**RE: Response to Approval with Modifications
[Revised] Investigation Report North Drainage Ditch and OW-29 & OW-30 Areas
Marathon Petroleum Company LP, Gallup Refinery
(dba Western Refining Southwest, Inc.)
EPA ID# NMD000333211
HWB-WRG-18-008**

RESPONSE TO COMMENTS

June 24, 2019 Approval with Modifications [Revised] Investigation Report North Drainage Ditch and OW-29 & OW-30 Areas (April 2019)

Title: **STORMWATER CATCH BASINS**
GALLUP REFINERY

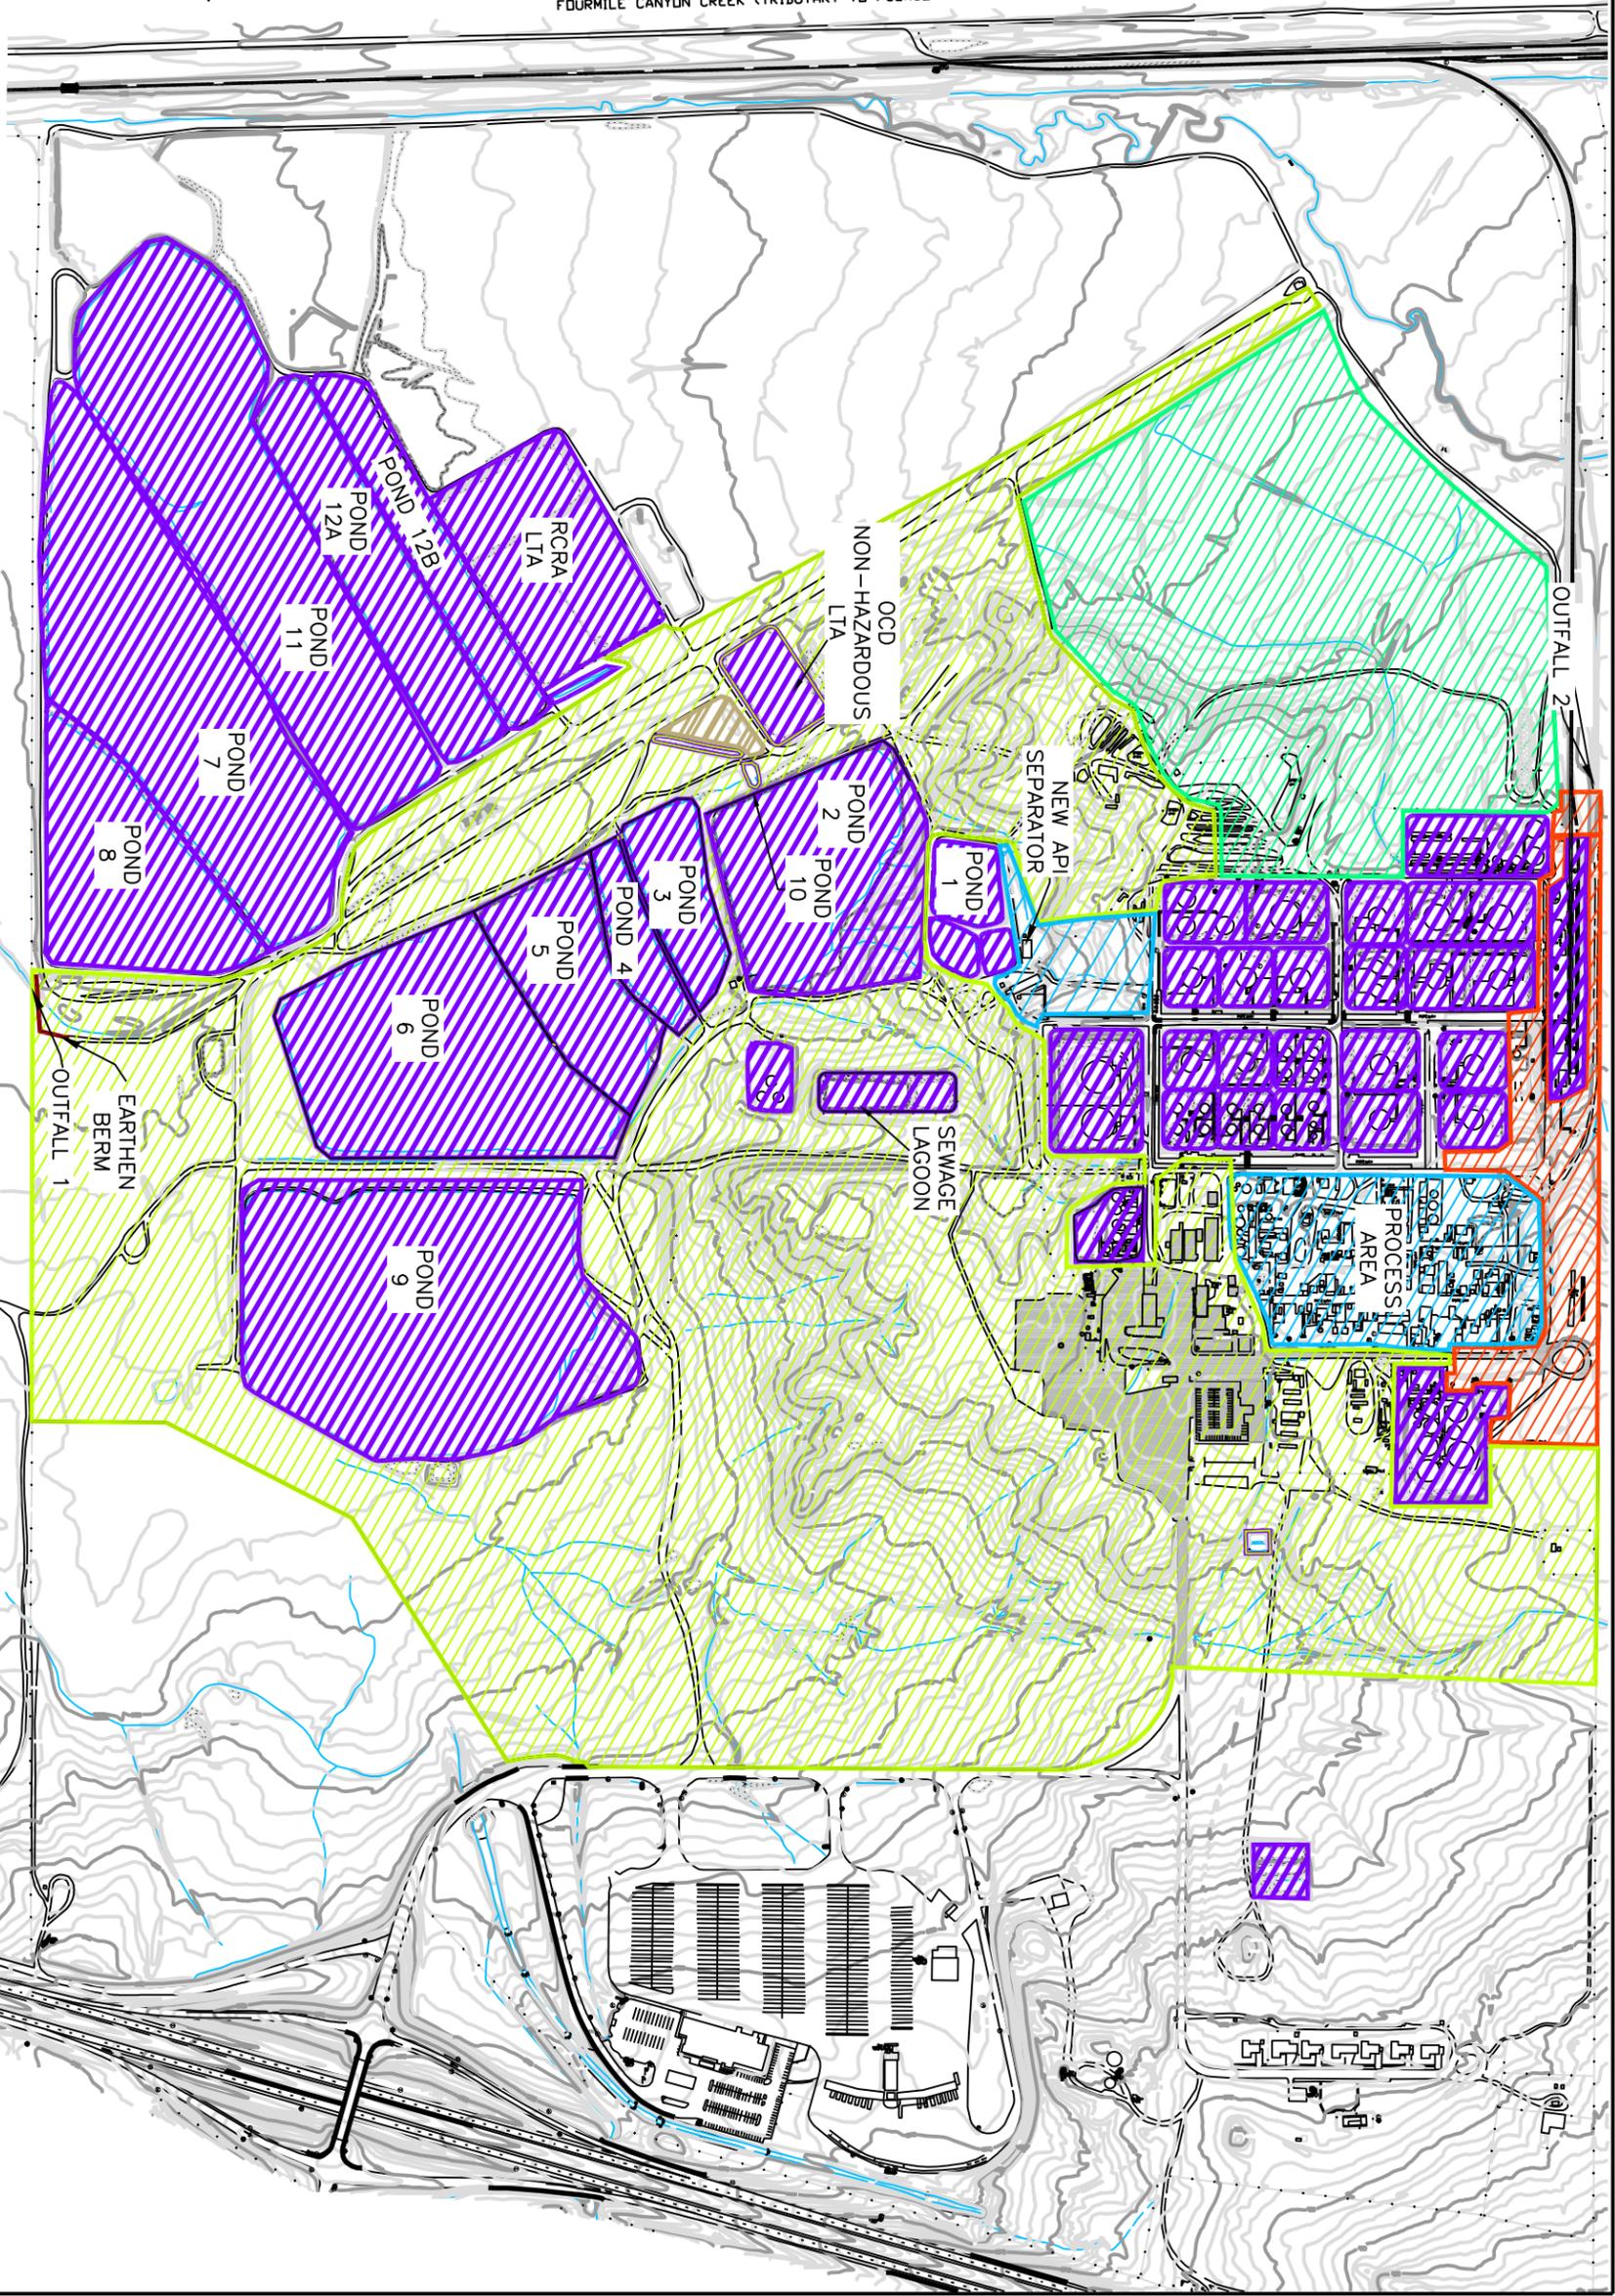
NMED Comment 10:

In Section 2.1 (North Drainage Ditch) the Permittee states that, "[a]t the western end of the North Drainage Ditch, as shown on Figures 2 and 5, the ditch basically ends and there is no clearly defined channel beyond this point. It appears any flow of surface water beyond this point would move to the north along the east side of a dirt road a short distance before crossing over the road and continuing west and then southwest eventually making its way to stormwater outfall #1." It does not appear that stormwater outfall #1 is labelled on the figures. Provide a figure that depicts the location of stormwater outfall # 1.

MPC Response 10:

Please find the requested figure enclosed.
